**Service Bulletin No.** RT20050520 Rev A  
**Subject:** Incorrect Choke Decal  
**Model:** MT74FA and MT84FA  
**Product Group:** RT  
**Date:** 05/20/2005

**SERVICE BULLETIN**

Choke Decal

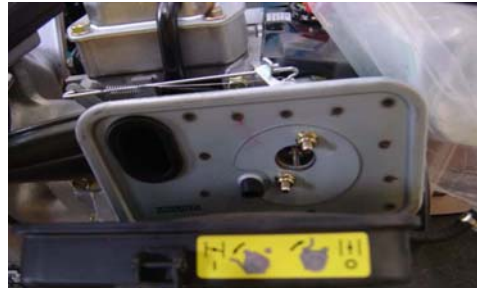
The MT74FA and MT84FA Rammers have an incorrect decal which is used to show the setting for the choke (the choke decal is pointing in the wrong direction). The correct setting is the opposite of what is shown on the decal. Please contact Multiquip to obtain the correct decal (Part No. 0732004430) needed to replace the original decal.

1) Remove the original incorrect decal.

2) Once the original decal is removed, make sure the surface is clean for the new decal.

3) Install the new decal (Part No. 0732004430).

4) Make sure the new decal points in the proper direction (see illustration to the right).
